London Oxford Airport Airspace Change Proposal

Consultation Feedback Report

Date: 26th October 2018

Osprey Ref: 70893 039

Figure 4 - GAA Proposed Alternative Airspace Design for LOA²

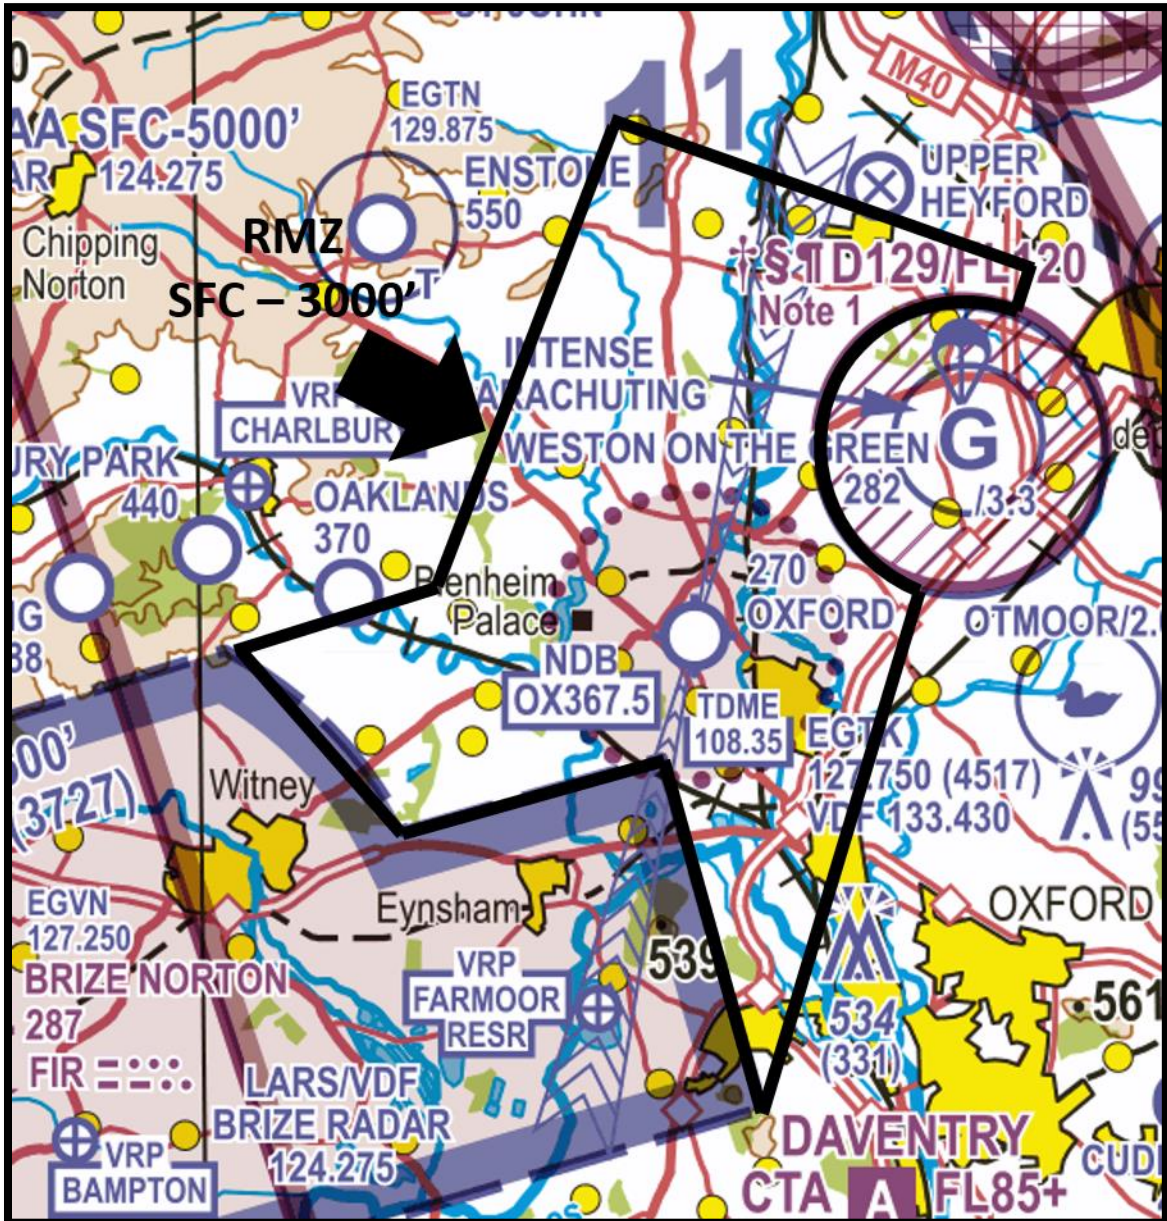
The General Aviation Alliance (GAA) objected to the proposal. They considered that the approach to consultation with aviation and non-aviation stakeholder was lacking. They were also disappointed that LOA did not form a Focus Group. The GAA considered that Class D is not necessary to achieve an acceptable level of safety for LOA's current and likely future operations. The GAA stated that the consultation document contained misleading information and did not properly assess the impact that proposed designs would have on the GA community. The GAA did not consider it appropriate for the ACP to continue under the CAP 725 process and stated that they have requested Government intervention.

The GAA provided a suggested alternative airspace design that would utilise a smaller area which is designated as an RMZ as shown in Figure 4 below.

Figure 5 - Consulted CAS Design Concept

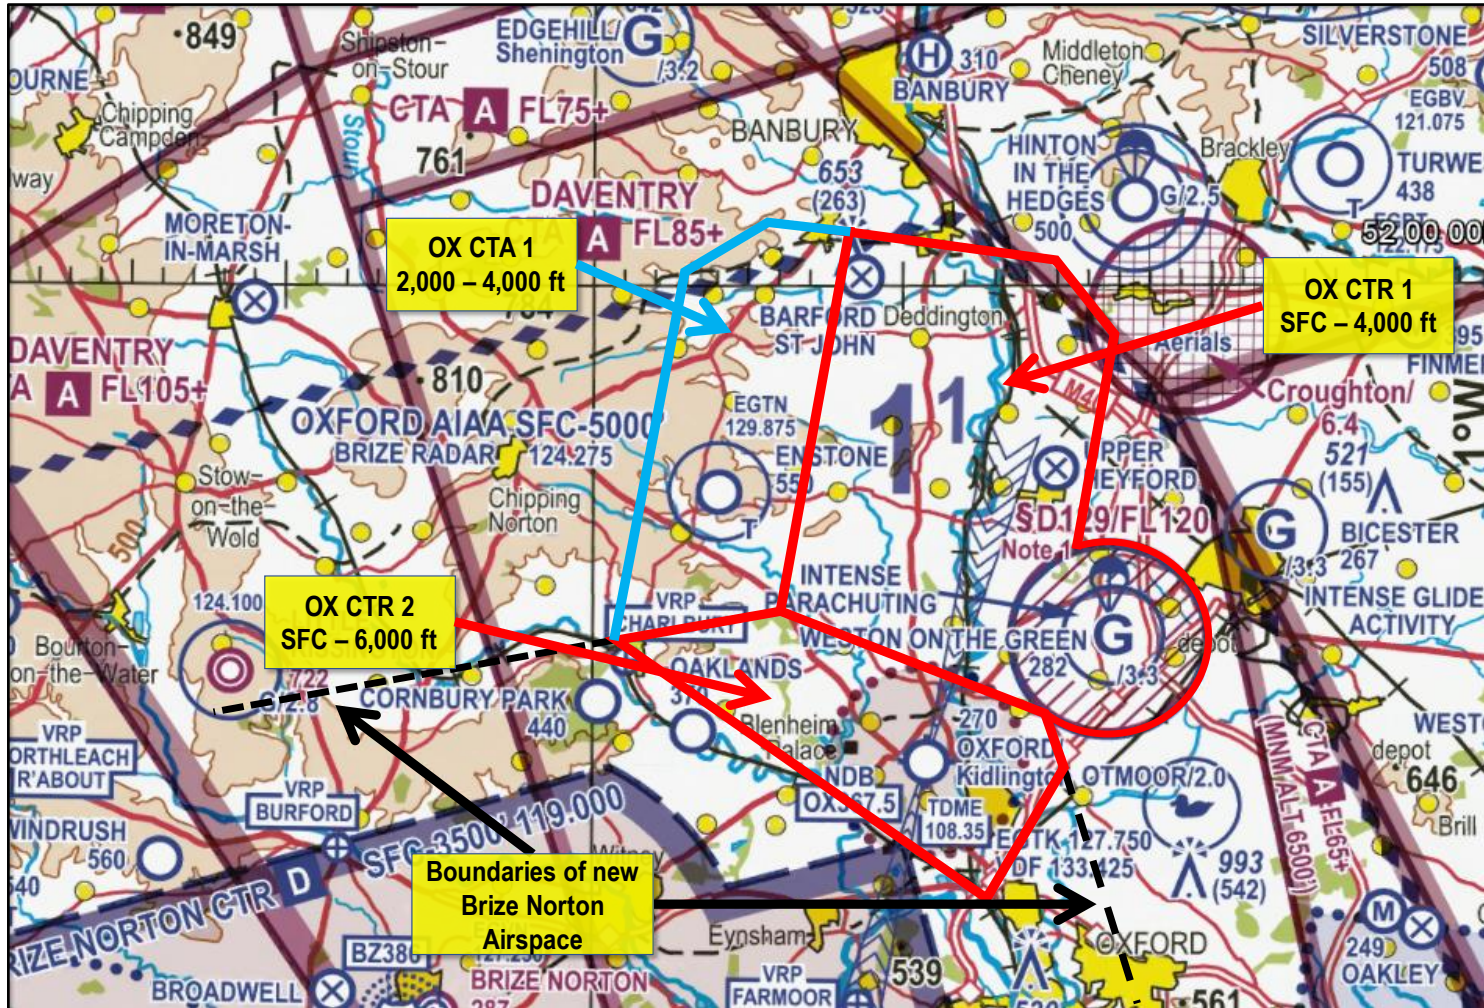
Figure 5 in Annex A3 depicts the design for the LOA CAS as proposed for the public consultation. A detailed review of the key themes raised in the objections can be summarised as follows:

In light of the objections received, LOA has re-evaluated the proposed design and intend to reduce the overall volume of airspace proposed, and to change the classification to an RMZ/TMZ to facilitate GA movements as fully as possible.
